Subject: U.S. EPR Design Certification Application RAI No. 133 (1456), FSARCh. 19

Request for Additional Information No. 133

U. S. EPR Standard Design Certification

Docket No. 52-020

Figure 19-246-12—RCS Pressure (Best Estimate)

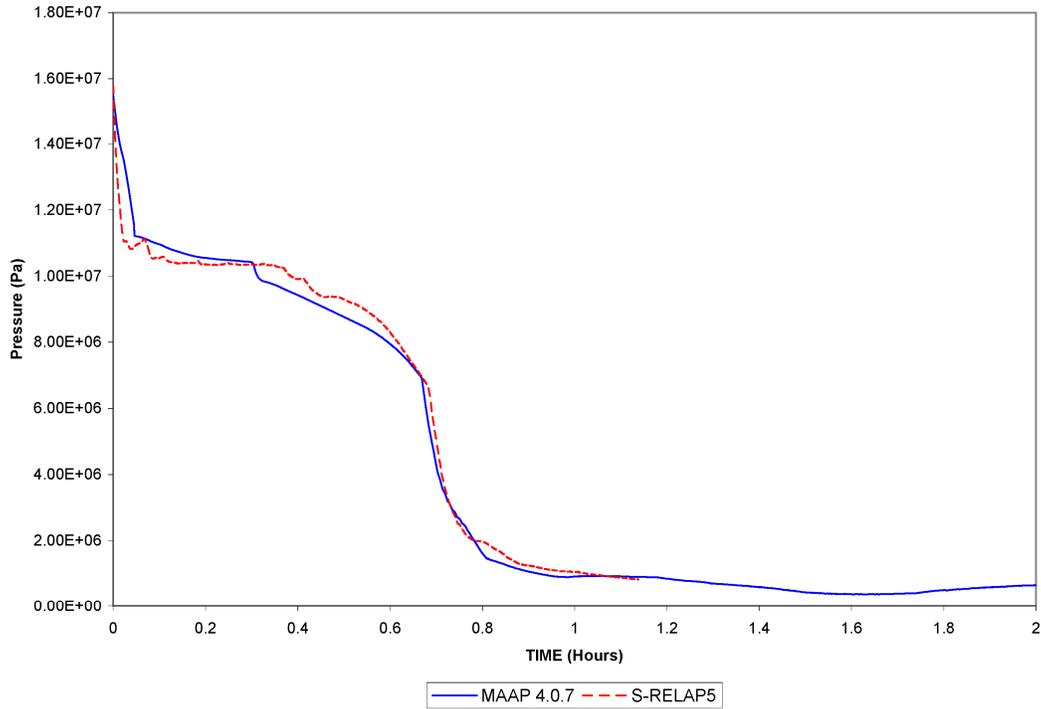
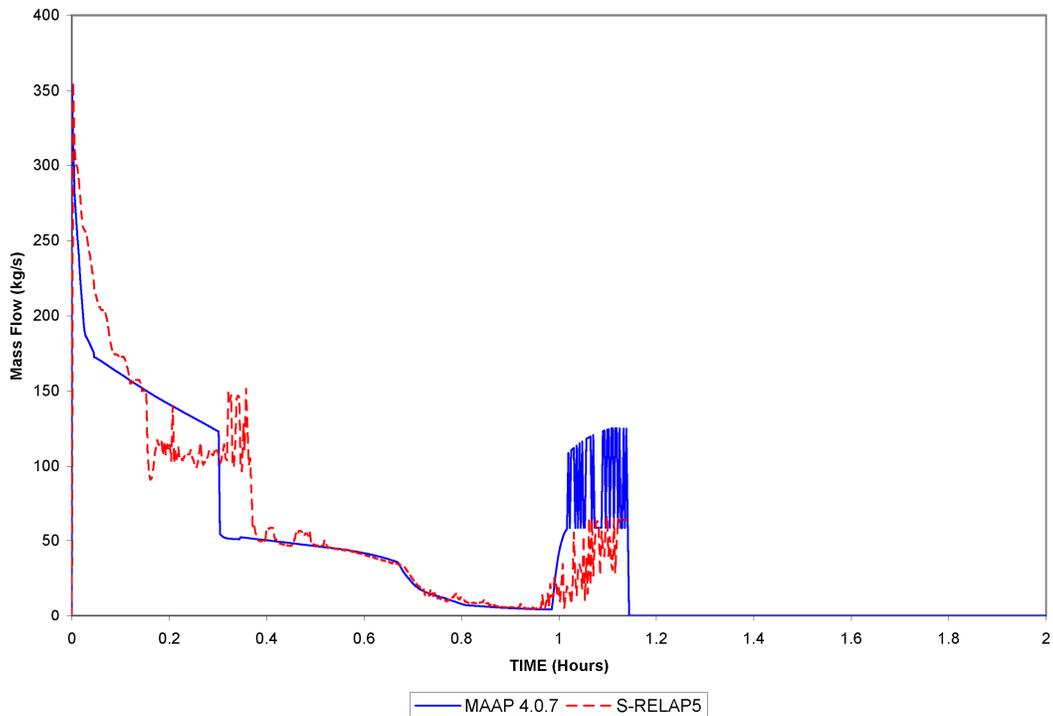
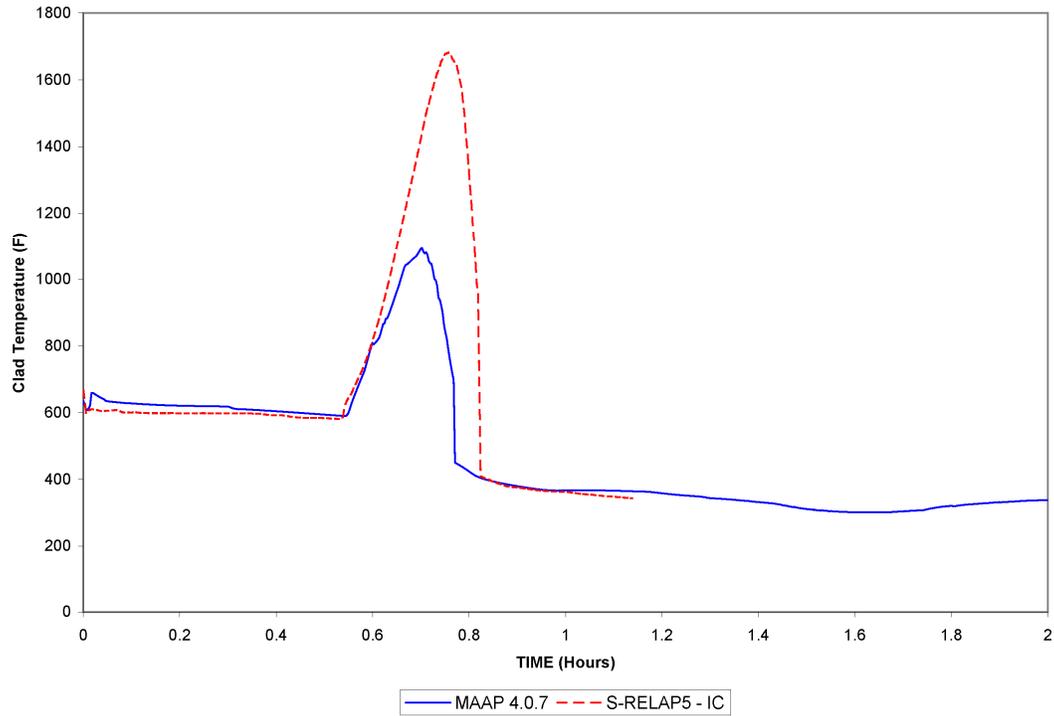
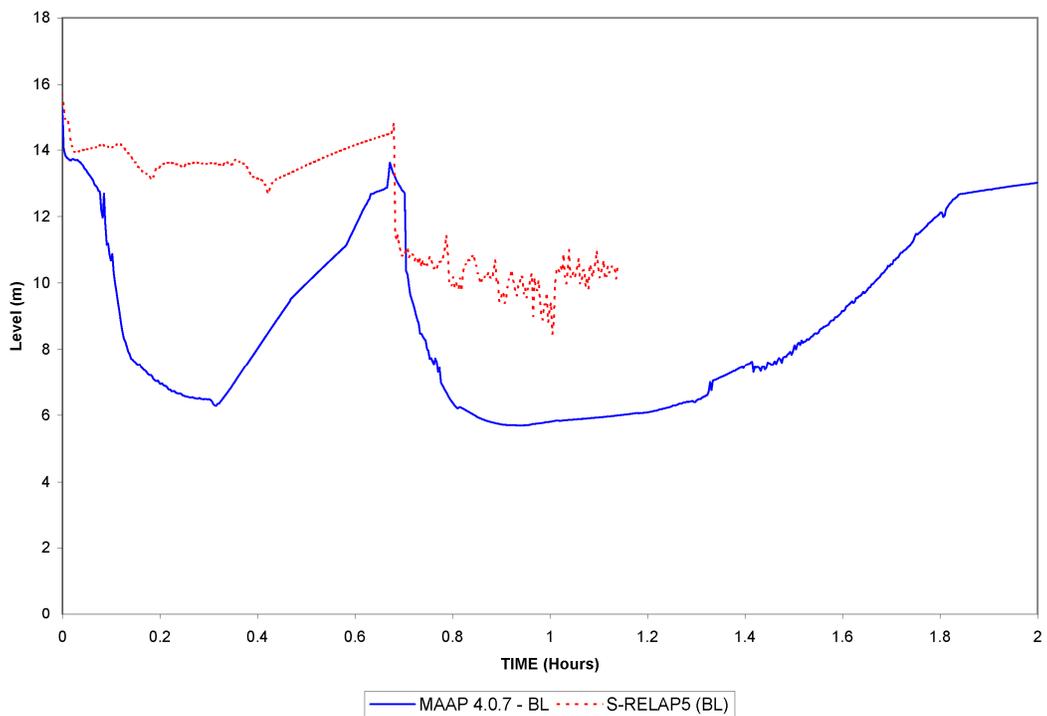
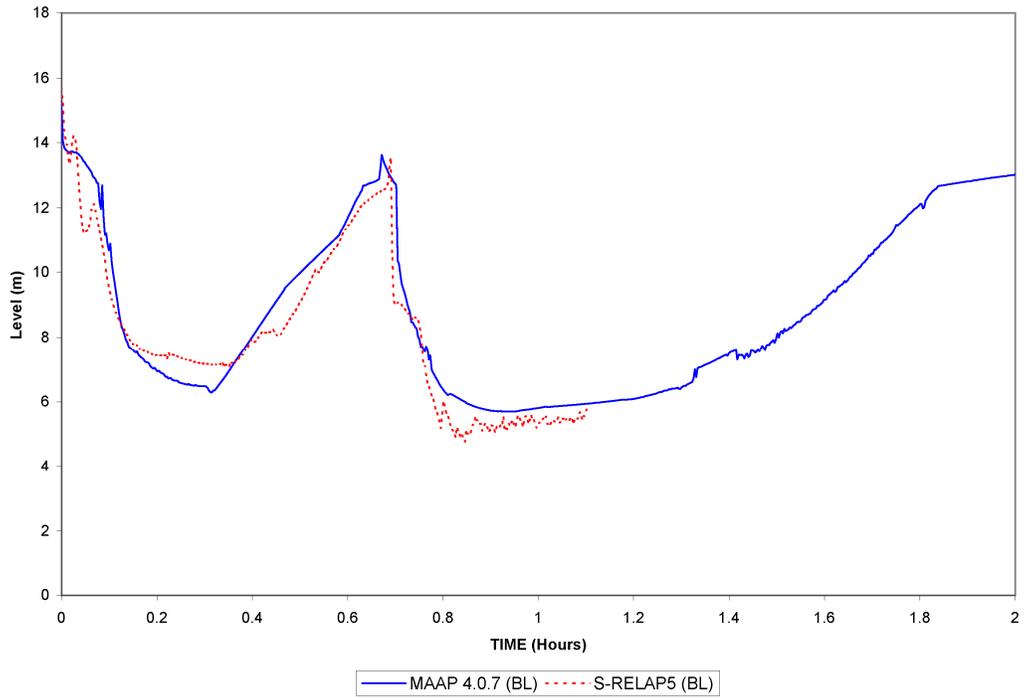
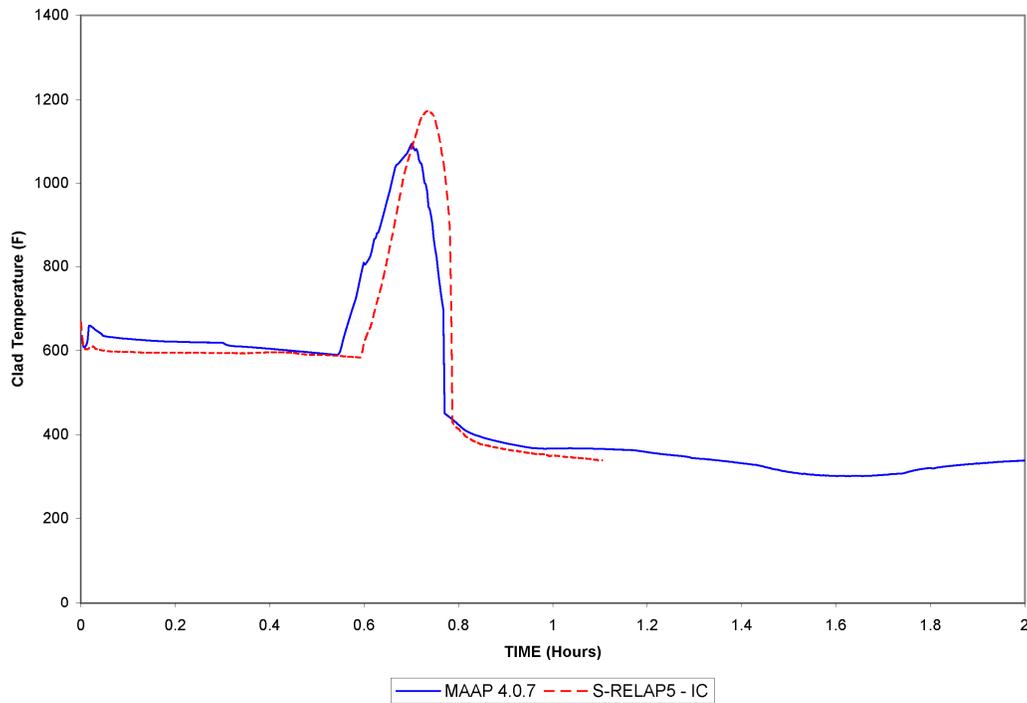
Please provide detailed results of the MAAP 4.0.7 and S-RELAP5 calculations to determine Level 1 success criteria. Also include the results of benchmarking MAAP 4.0.7 against S-RELAP5 and explain how the benchmarking was performed. As part of your discussion:

Figure 19-246-12 shows the primary system pressure. Both the trends and magnitudes of pressure are similar. Figure 19-246-13 shows break flow and, like pressure, shows good agreement in magnitude and trend. The eventual consequence of the LOCA is to reduce the RCS inventory and similarly the reactor vessel inventory.

Core uncover occurs in both MAAP4 and S-RELAP5 simulations, which results in rising fuel temperatures as shown in Figure 19-246-14. The core temperature is not reduced until operators initiate fast cooldown by opening an MSR. Steam generator liquid level, shown in Figure 19-246-15, reflects the consequence of the fast cooldown in terms of coincident steam generator liquid level drop.

The main differences between the MAAP4 and S-RELAP5 in this case are the magnitude of the core temperature excursion and the steam generator liquid level. In Figure 19-246-15, the steam generator liquid level, the code result comparison indicates a significant difference in primary-to-secondary heat transfer. In the MAAP4 calculation, an initial high primary-to-secondary heat transfer period is evidenced by an early steep drop in level. The S-RELAP5 result shows an initial low primary-to-secondary heat transfer period prior to the fast cooldown. Even during the fast cooldown, the liquid level predicted by S-RELAP5 does not decline at the same rate as in the MAAP4 simulation. Since S-RELAP5 predicts low primary-to secondary heat transfer, water from the EFW contributes to this slower response through increased coolant inventory and lower coolant temperatures.

Leaving the one RCP running for 20 minutes in the S-RELAP5 simulation improves the magnitude and trend of the steam generator liquid levels as shown in Figure 19-246-16. Consequently, relative magnitude and trending of the fuel temperatures are also improved. The PCT comparison shown in Figure 19-246-17 shows a difference of 100°F.
